# ES\_LPC177x/8x

## Errata sheet LPC177x/8x

Rev. 2.2 — 17 January 2012

Errata sheet

Fig 2. RTC.1 work-around

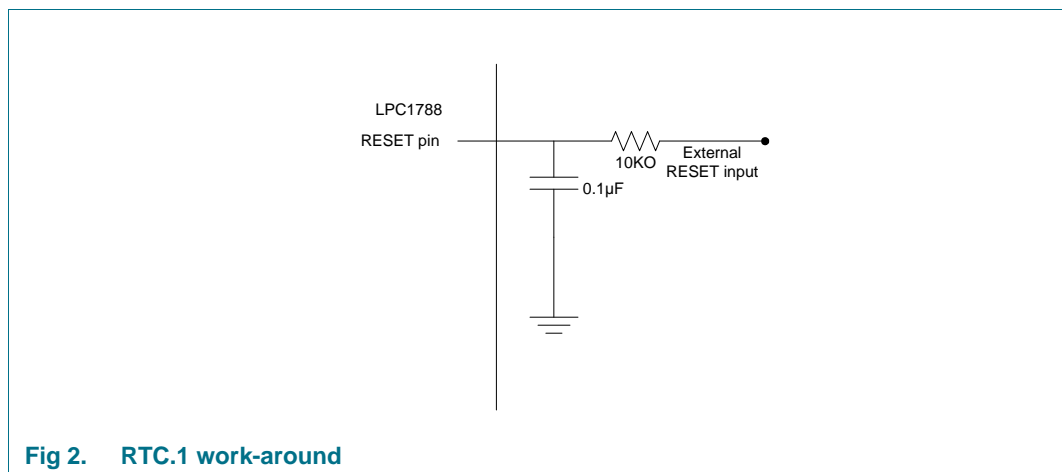
RTC temporarily pauses and loses fractions of a second during the rising and falling edges of RESET. This occurs only in the LQFP packages with certain voltage swings and ramp rates. The problem is exacerbated by low temperatures. Reducing the voltage swing and/or ramp rate of the reset pulse will eliminate this loss of time counts. When this issue occurs, the impact on RTC accuracy is expected to be one second every several thousand reset events.

Adding an RC filter between the reset pin and the external reset input to control the reset signal voltage ramp rate can prevent this problem.
